**RE: Response to Pre-Bid Question for State Project No. 0158-0211**

Subject: Route 15 Safety Improvements Resurfacing Enhancements and Bridge Improvements & Rehabilitation of Bridge No. 00728 Merritt Parkway Over Saugatuck River - Question # 24

**Allowed load configuration after the rehabilitation (steel and concrete repairs)of Bridge 00728 has been completed**

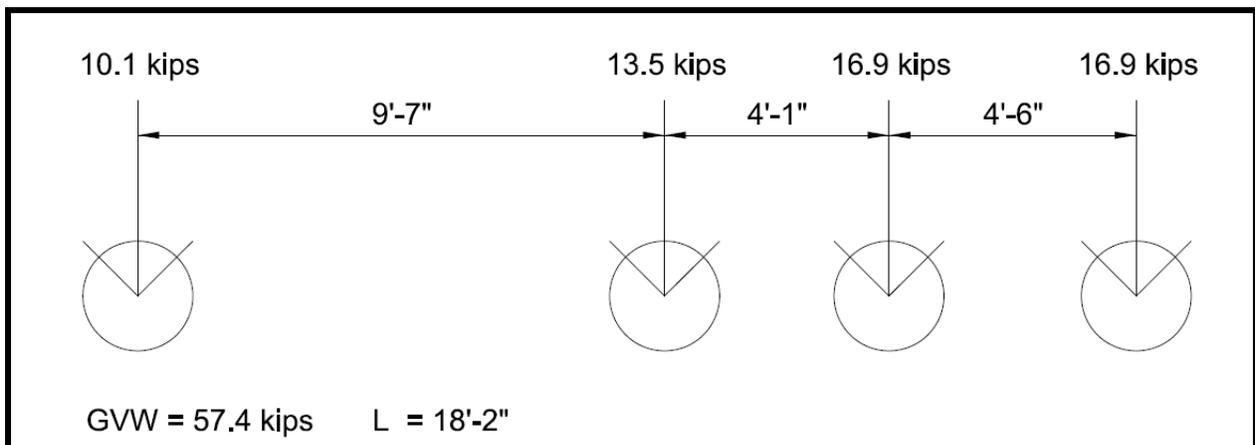
On sheet 05.03.04 in the section " Construction Loading Restrictions # 3 Vehicular live load restrictions" it states that only one truck at a time can cross bridge 728 and that the loading cannot exceed H-10 loading without a submission and review of the anticipated axel loads. Could you please tell the bidders the maximum allowable GVW for a triaxle truck. The milling and paving between sta 1030+00 and 1074+00 will be severely impacted if the triaxle trucks cannot carry their full weight or if triaxle truck cannot be used at all when crossing bridge 728.

The following 4-axle vehicle was checked as the triaxle truck for the vehicle engaged to be used in construction work.

After performing a load capacity evaluation, **75% of GVW for 4-axle load (57.4 kips) will be allowed on the bridge after ALL rehabilitation work (structural steel and concrete repairs) have been completed and approved.** During the rehabilitation work of Bridge 00728, no load heavier than the a H10 loading will be allowed on Bridge 00728, unless otherwise approved. The Contractor is required to submit all trucks that are expected to traverse the bridge (including the restrictions under which such load will traverse the bridge like lanes restricted etc.) for approval if it exceeds an H10 loading.
